STAFF REPORT ACTION REQUIRED

Application for Fence Exemption 44 Fairlin Drive

Date:	December 8, 2009
To:	Etobicoke York Community Council
From:	Curtis Sealock, District Manager, Municipal Licensing and Standards
Wards:	Ward 5, Etobicoke-Lakeshore
Reference Number:	ML&S Folder Number 09 154718 FEN 00 IR

Attachment 2 – Pool Enclosure – Fence Layout

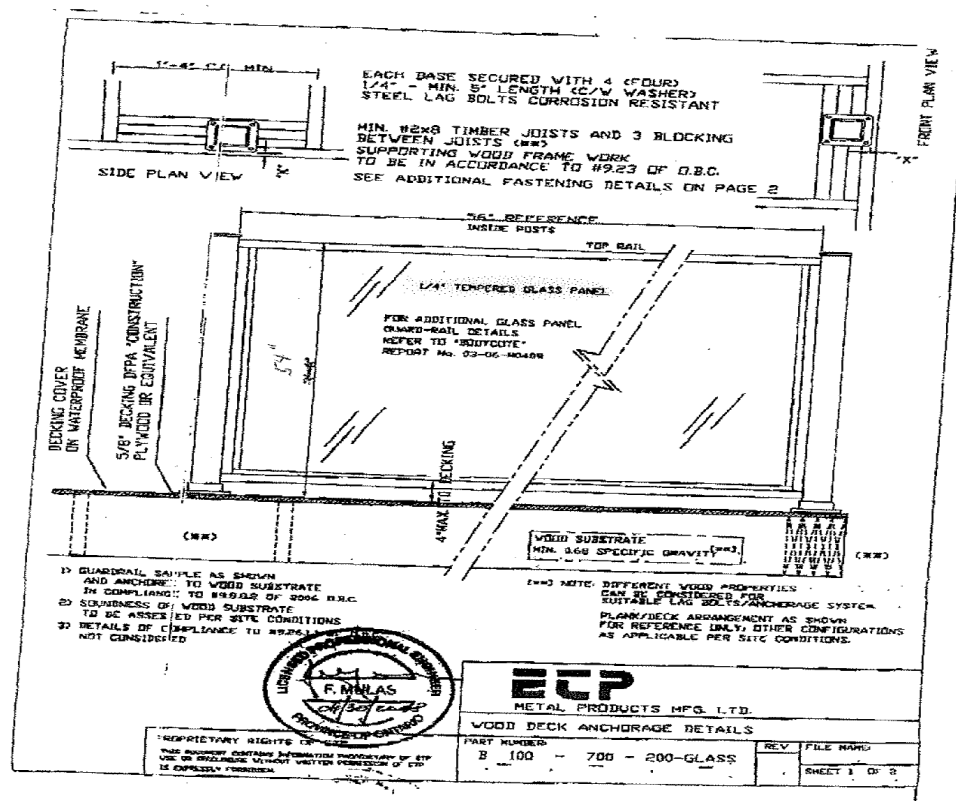
The fences permitted under the current edition of the Fence By-law include a chain link fence of 38 millimetres mesh size, a wood fence made up of close vertical boards, and a metal picket fence. The fences and gates for the pool enclosure at this property as made up of glass, horizontal wood slats, and chain link fence of 50 millimetres mesh size are not permitted in Toronto Municipal Code, Chapter 447, Fences.

1. The tempered glass fence, guards and gates shall be installed in accordance with the Manufacturer’s and Engineer’s specification.
2. All gates shall be self-closing and self-latching, and provided with a latching device installed on the pool side, over the top of the gate, to the latch on the pool side.
3. The perimeter iron fencing and horizontal wood slat fencing shall be constructed and maintained in the manner that they are not climbable.

4. The pool enclosure as well as the landscaped garden shall be constructed in accordance with the Toronto Municipal Code, Chapter 447, Fences, and the Ontario Building Code.
5. The existing temporary fence shall remain in place when the pool is filled with water, until the Fence Exemption is approved and the fence enclosure completed and inspected in accordance with Toronto Municipal Code, Chapter 447, Fences.
